COTTAGE GROVE CITY COUNCIL
12800 RAVINE PARKWAY SOUTH
COTTAGE GROVE, MINNESOTA 55016
COUNCIL CHAMBER - 7:00 PM

January 21, 2026

- M Van Meter Site Plan Review for Building Expansions and Variance Request
Staff Recommendation: A) Adopt Resolution 2026-016 to approve the variance to allow the proposed building addition for Expansion A to be 64 feet from the north property line when a 100-foot setback to the residential property line is required, located at 7450 95th Street South. B) Adopt Resolution 2026-015 to approve a site plan review for two building additions and associated site work for Van Meter Inc. located at 7450 95th Street South. C) Adopt Resolution 2026-023 rescinding, terminating, and releasing the Stormwater Management Agreement recorded July 16, 2015 as document number 4033928. D) Approve the Encroachment Agreements for items within the drainage and utility easements, Stormwater Management Agreement, and the Hydrant Access Easement Agreement for Van Meter Inc, located at 7450 95th Street South.

C200

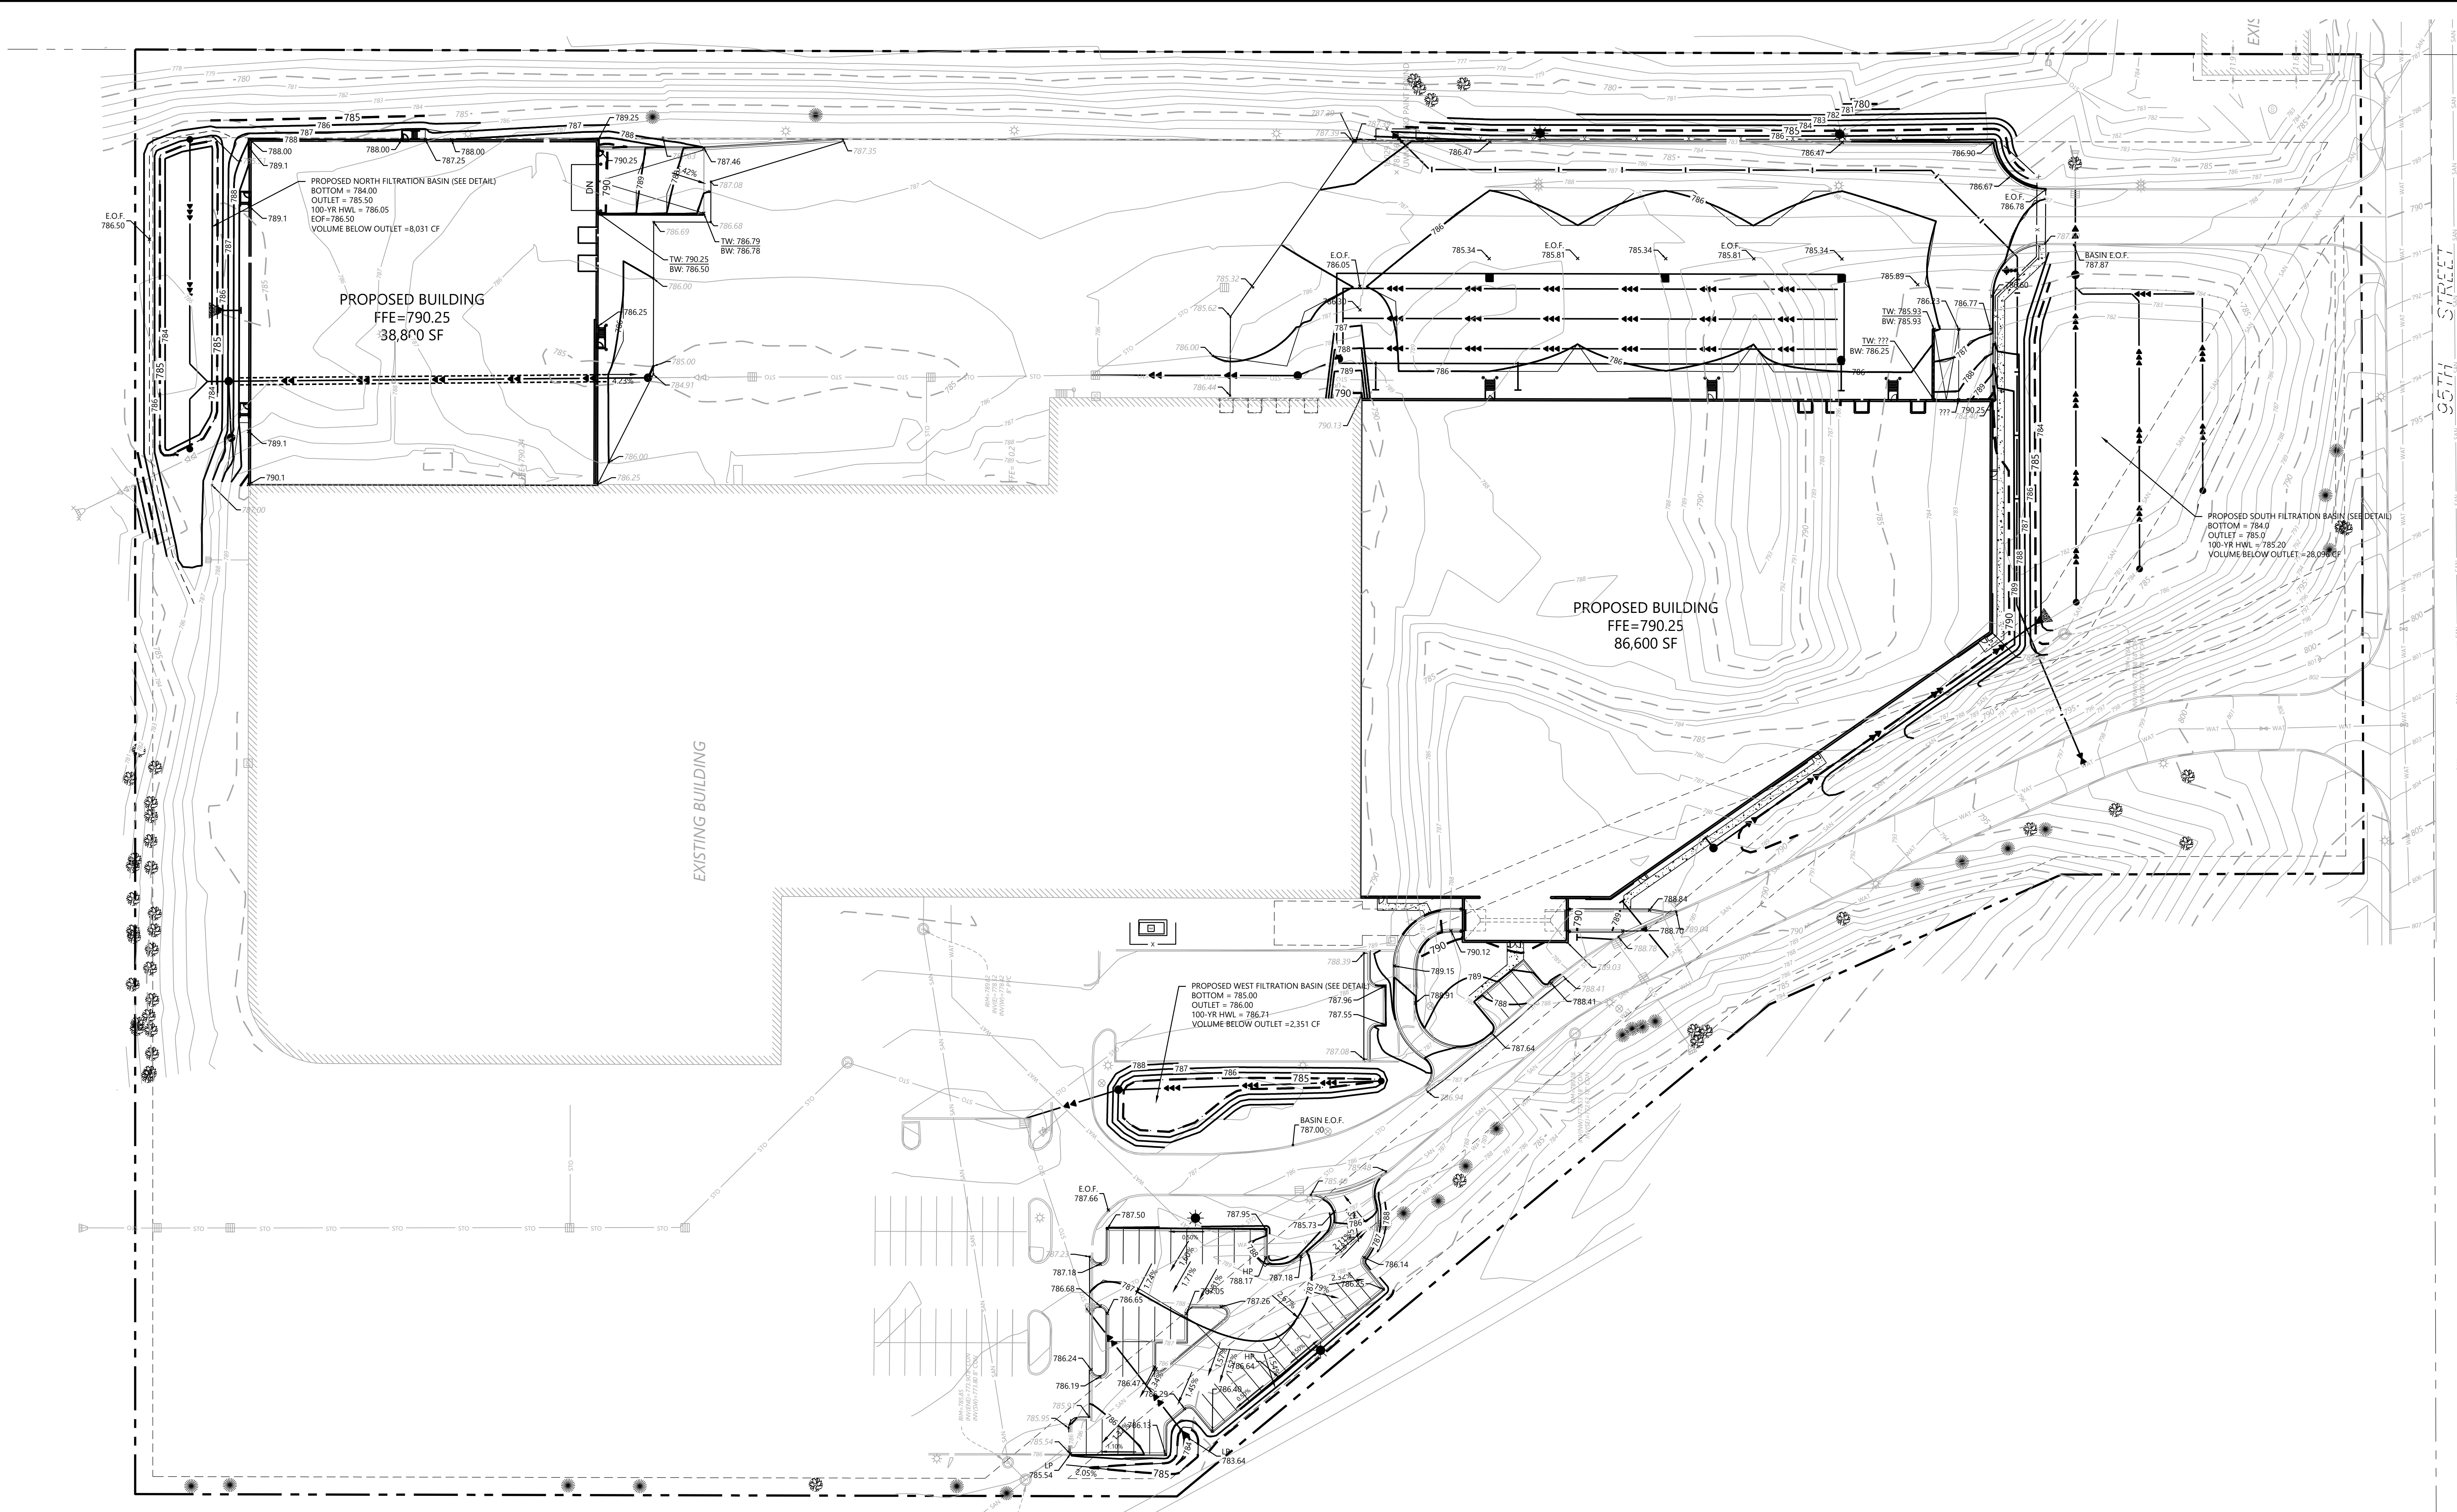
2. Fencing:
 - a. Keynote A31 on Sheet A1.1 states to see Civil sheets for chain link fence. New fence does not appear to be identified on civil sheet C200 in this particular location of the site, rather, the generator is just to the north. Please clarify or make the sheets consistent.
 - b. Keynotes H & I identify fence type; please provide details of each proposed fence for review.
3. The proposed parking lot expansion encroaches onto the drainage and utility easement for the trunk sanitary sewer; the city will prepare an encroachment agreement.

C500

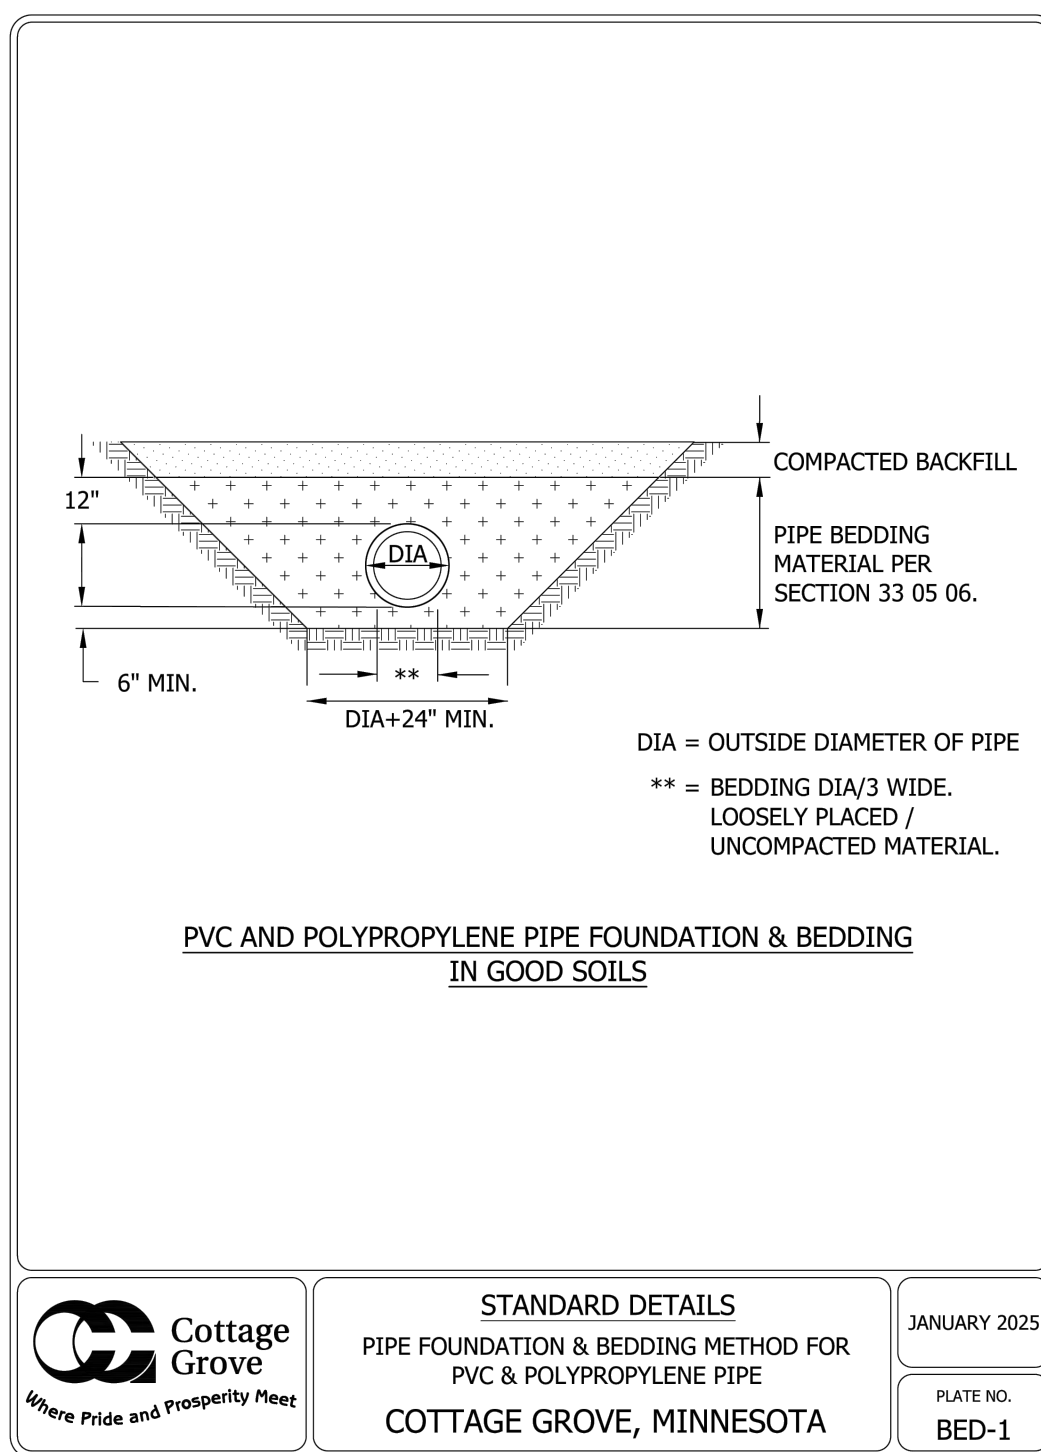
- 7. Sanitary Sewer: Instead of an inside drop manhole, a Kor-N-Tee connection is preferred (include city standard detail SER-8).
- 8. There does not appear to be a new water service to the building. Respond as to where water will be extended from (within the existing building or other).
- 9. East side of property: new lights, hydrant, and fence are all proposed in the public drainage and utility easement. The city will prepare an encroachment agreement.
- 10. Utility note #14.E: clarify if CMP pipe is proposed anywhere on the site.

- c. The pipe outlet of OCS-22 on Sheet C500 is labeled as 30" but the detail on Sheet C601 and the HydroCAD model indicate this pipe is 36". Please revise the pipe size on C500 to 36" to be consistent.

- d. The underground filtration system outlet is listed as 782.60' on Sheet C500. The OCS-22 notes list rim elevation and invert, but no outlet information. Please include details for outlet structures in the plans. Provide a storm schedule identifying structure sizes, sumps, etc. Sump structures should be provided prior to discharge into a stormwater basin.
